ADDENDUM NO. 1
NDOR / ADA FACILITY UPGRADES
REST AREAS – SEGMENT 1
HGM PROJECT NO. 180014
NDOR PROJECT NO. AFE W-002

DATE OF ISSUE: Monday, October 06, 2014

CHANGES TO DRAWINGS

project no. 180014
 ADDENDUM 1
 sheet C12
 46701

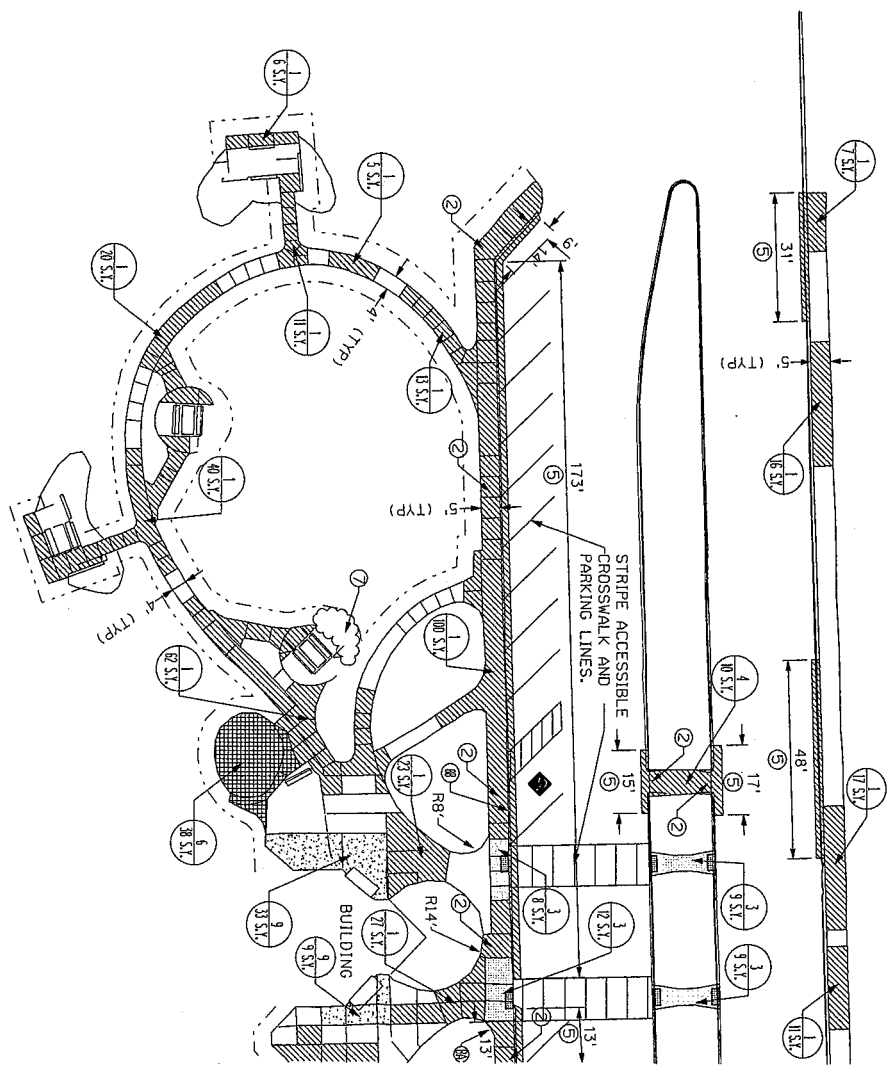
SHEETS C1.1, C1.2, C1.3 of 46701 – York EB RA, attached.

Quantities and Locations of Sidewalk Removals and Replacements have been modified.

Quantities and Locations of Curb and Gutter Removal and Replacements have been modified.

Refer to 46701 – York EB RA Revised Schedule of Values for Quantity Changes.
